Town of Ridgeland

PROJECT: Town of Ridgeland Water and Sewer Resiliency Improvements
TOR-2023-02

ADDENDUM: Three (3)

A10.4

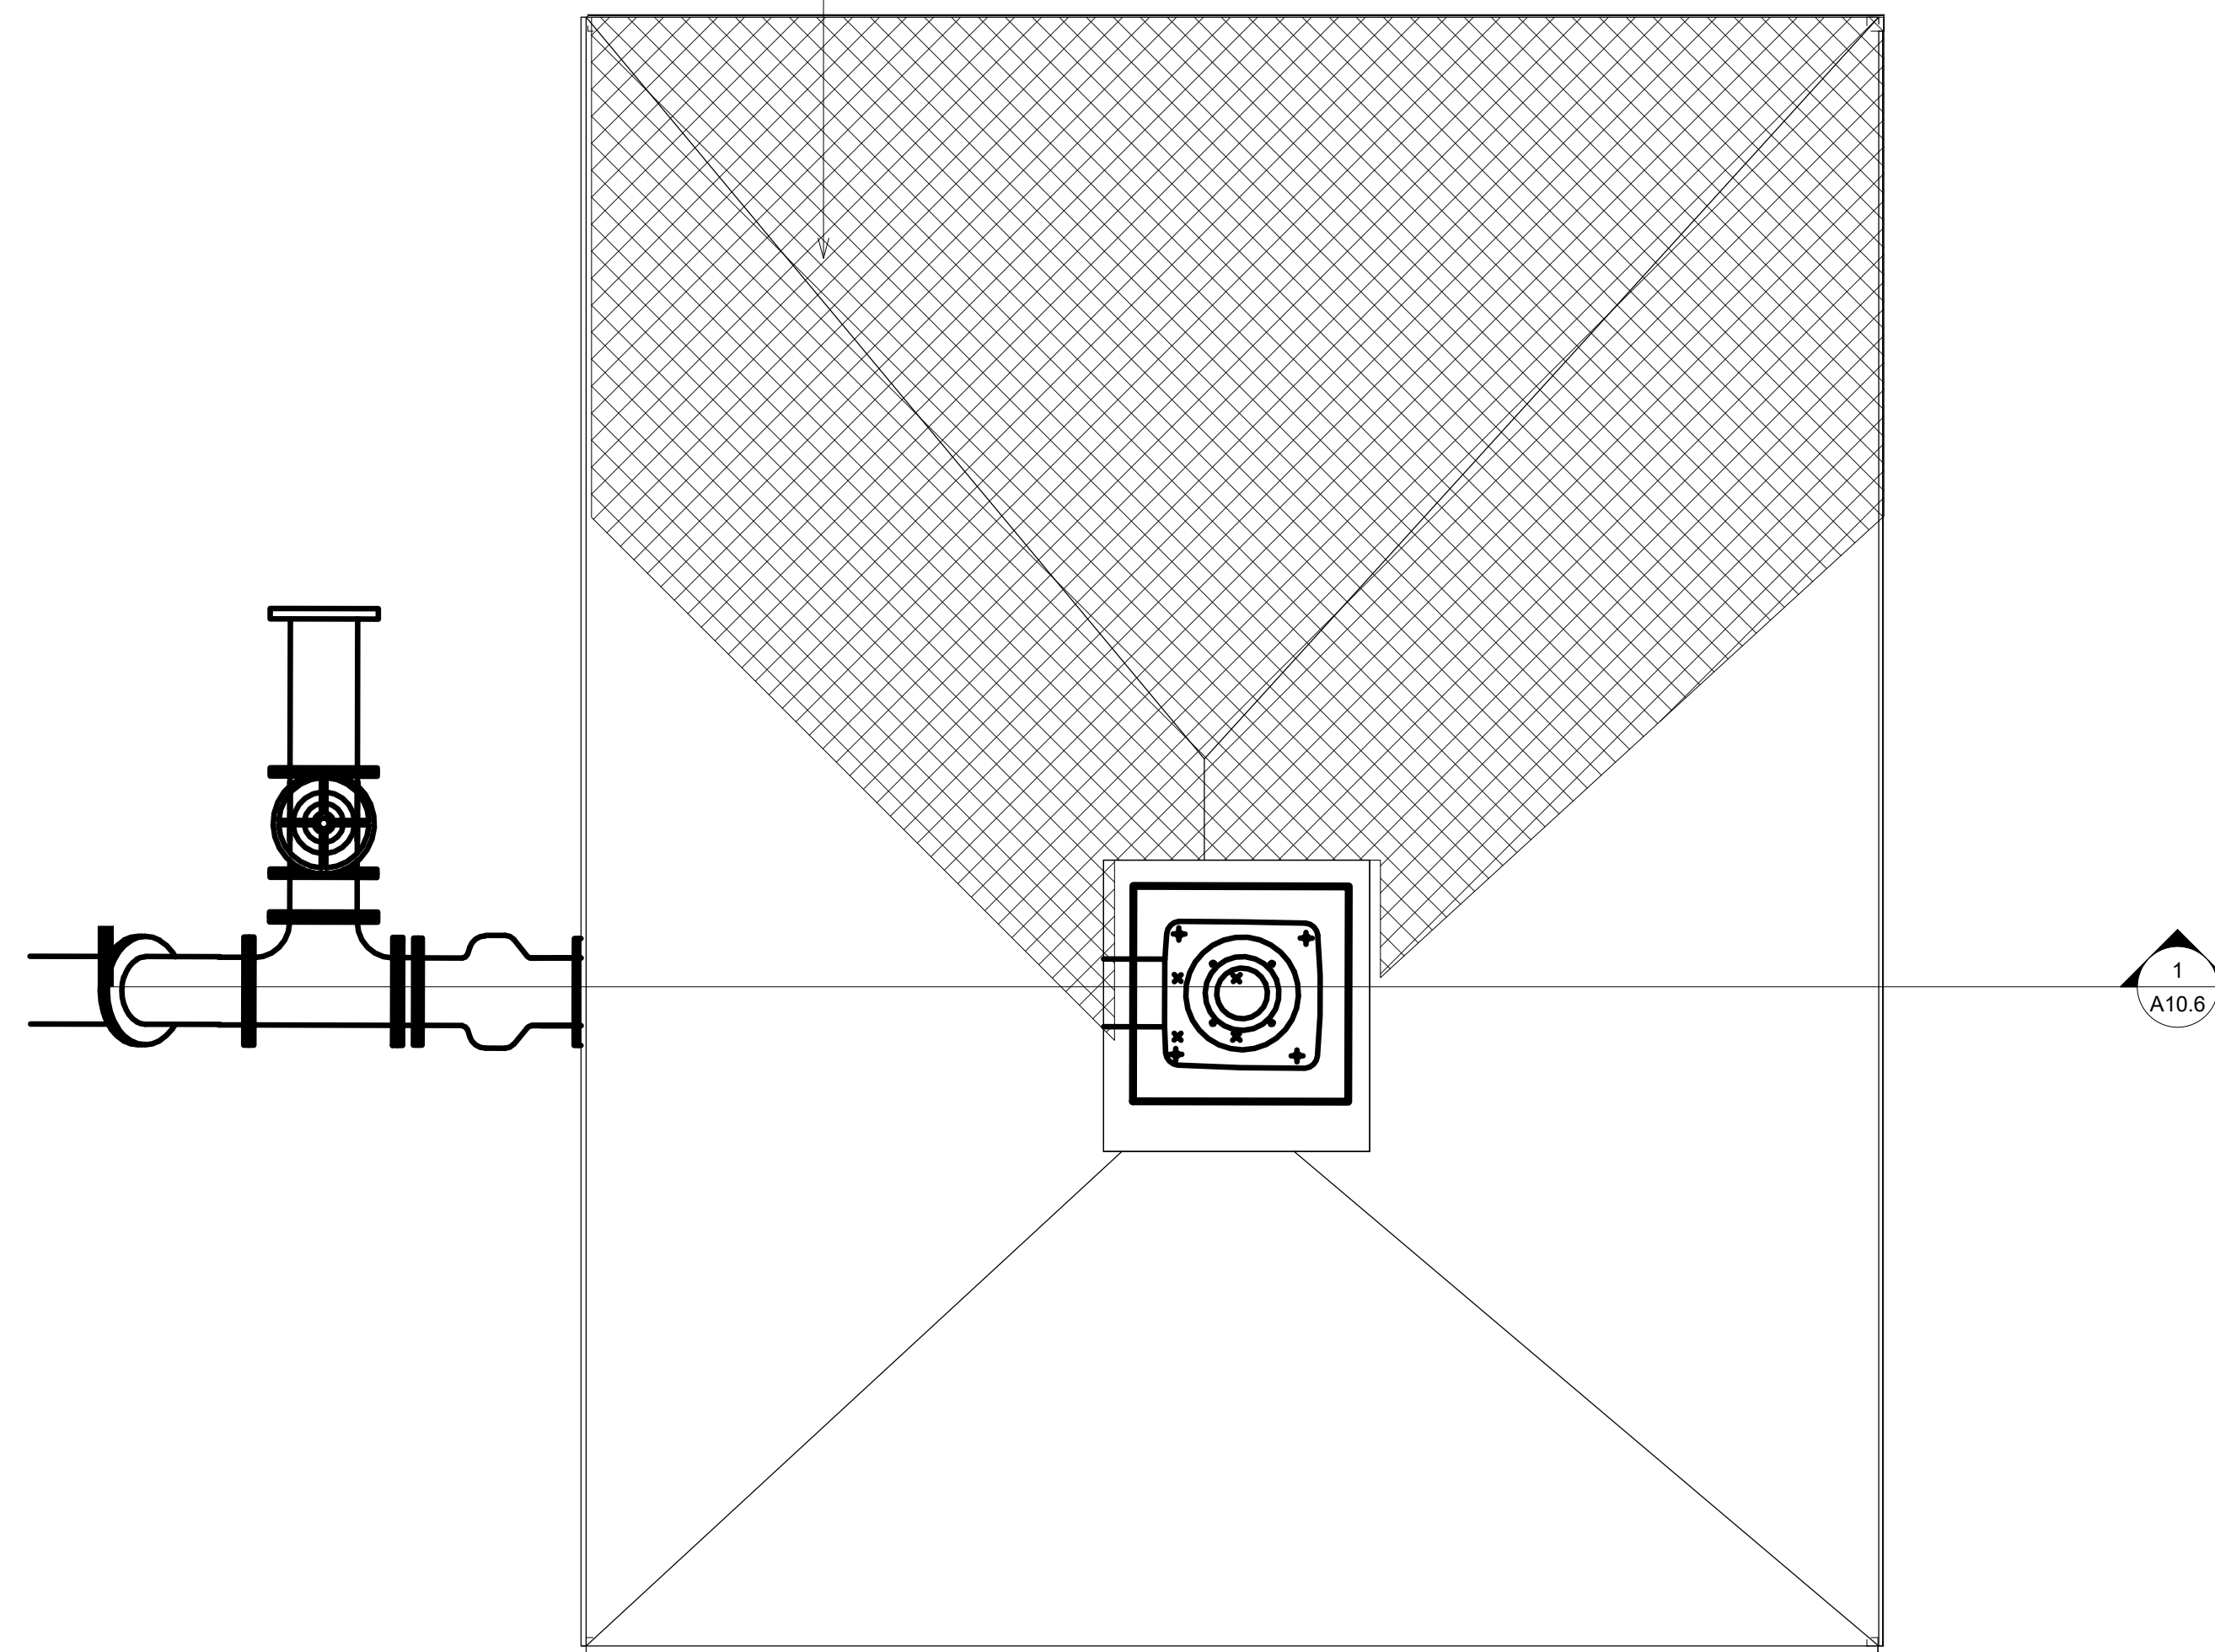
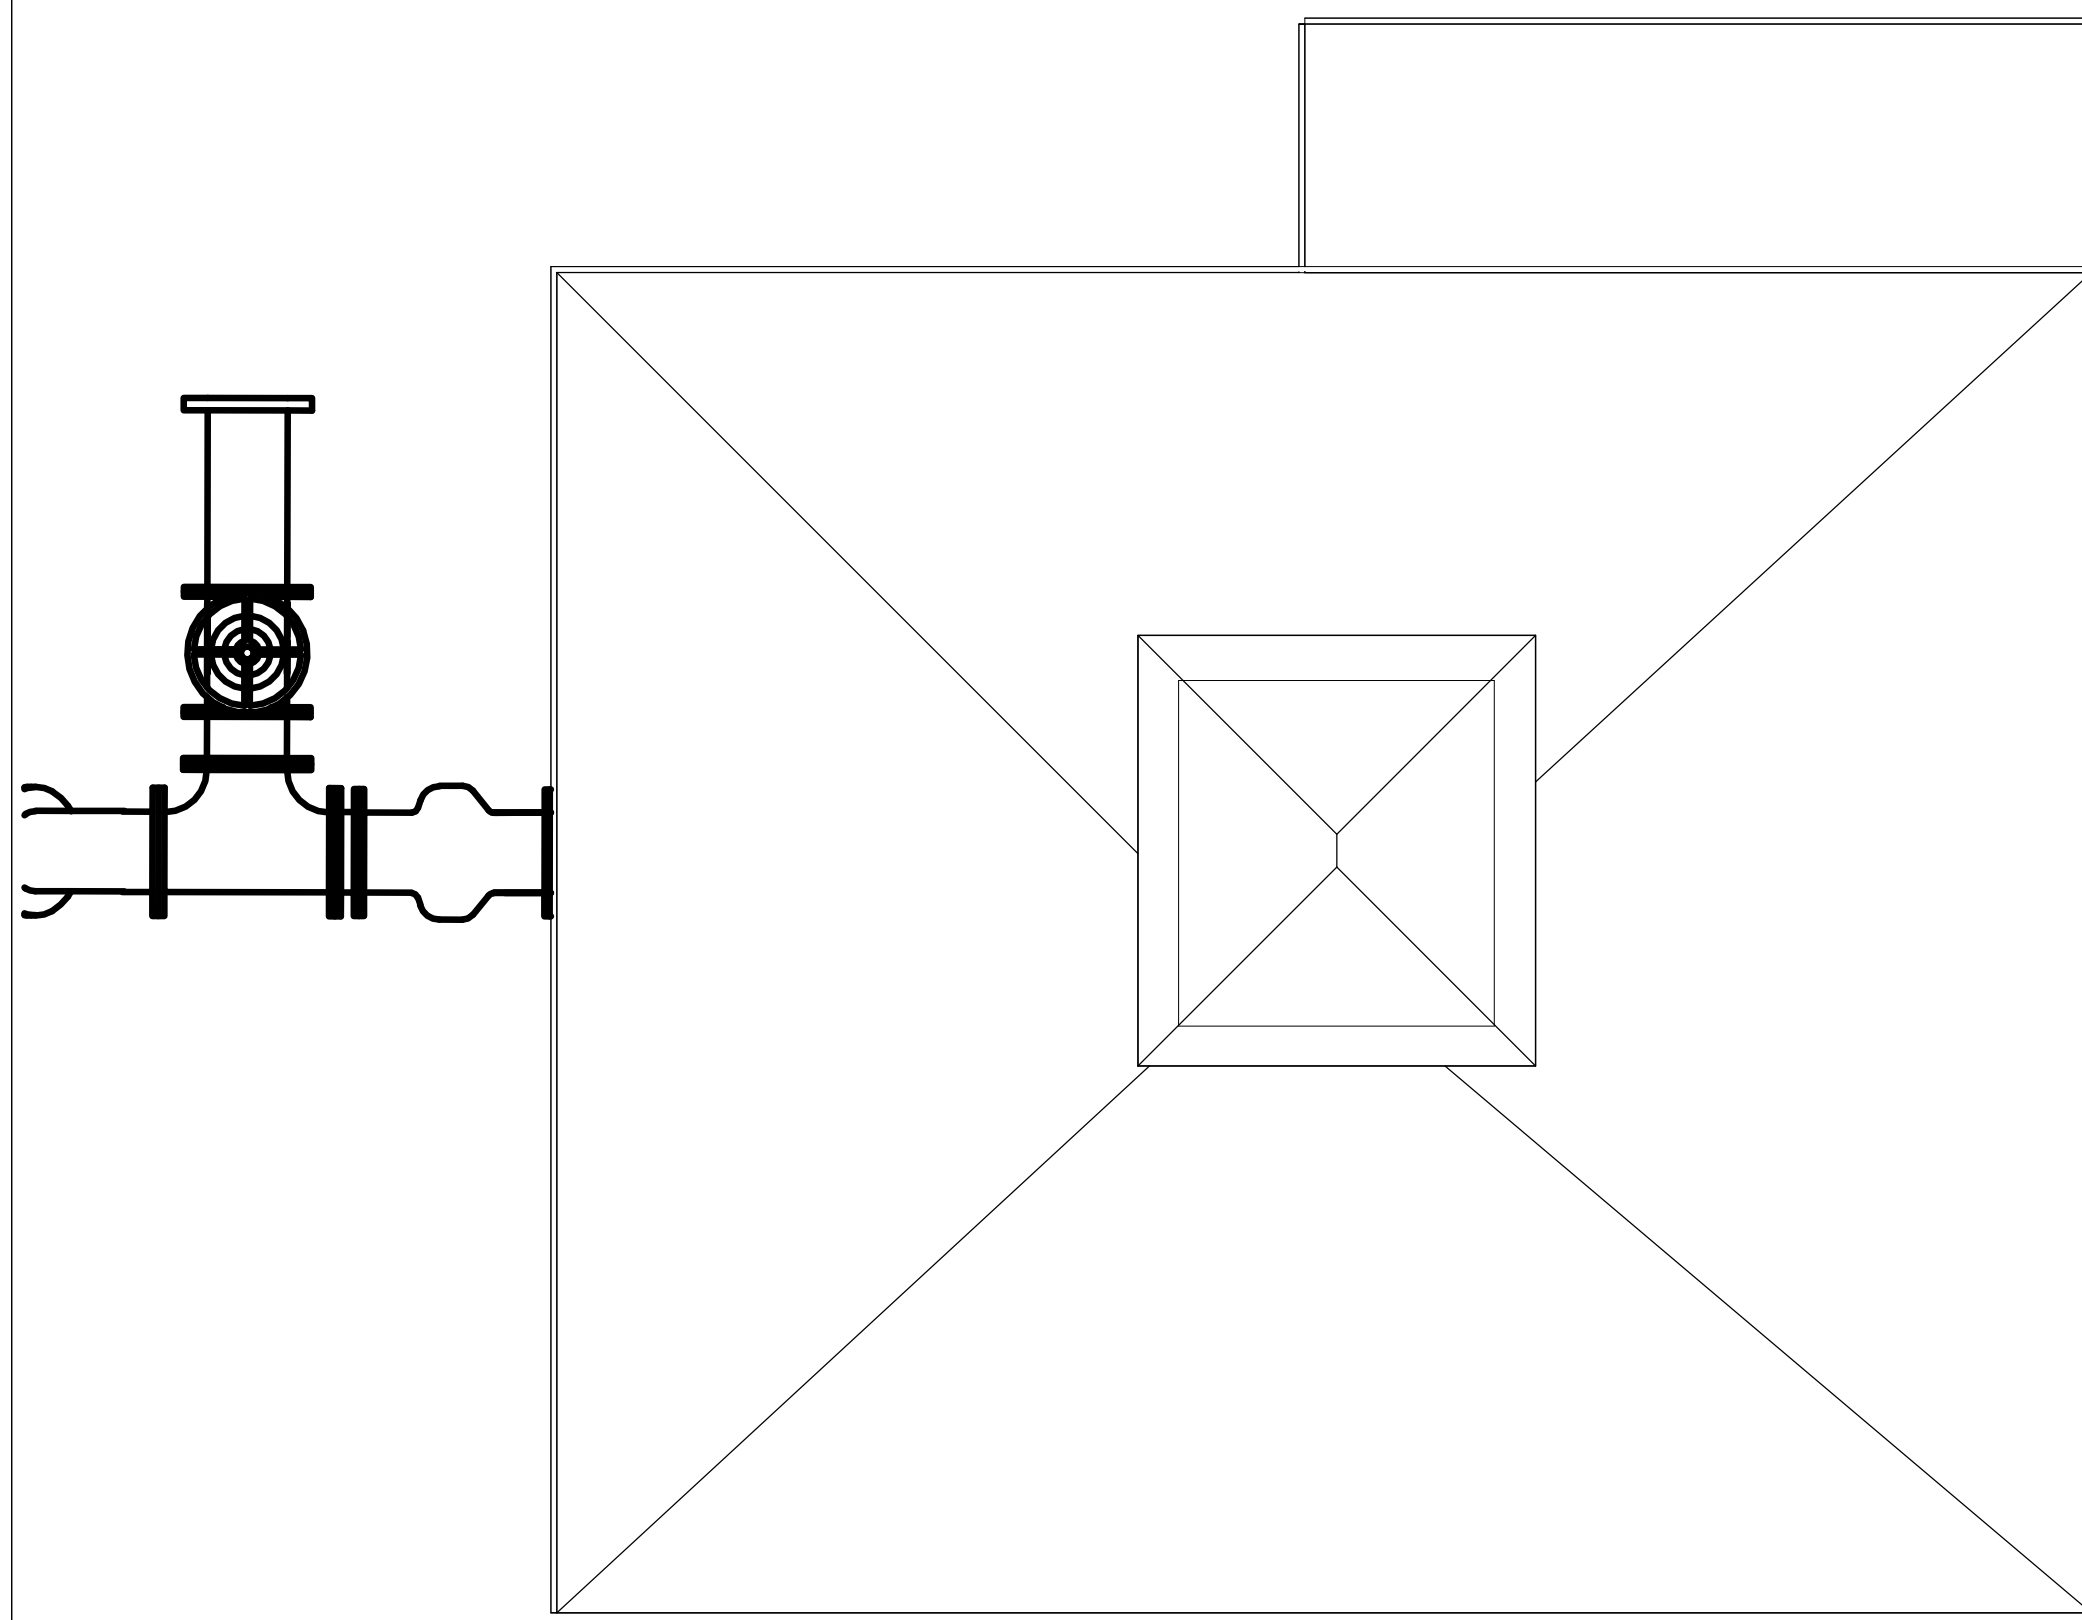
- i. A10, A10.1 – A10.7 Architectural improvements updates to correct dimensions of the existing building and to modify and increase the size of the proposed building expansion for the chemical room.
- ii. S100, S101, and S201 Structural improvements updates to correct dimensions of the existing building and to modify and increase the size of the proposed building expansion for the chemical room.

AREA OF ROOF MODIFICATION. REFRAME AREAS TO OBTAIN EXTENSION AS SHOWN. MAKE PROVISION TO PROTECT INTERIOR EQUIPMENT WHILE REFRAMING.
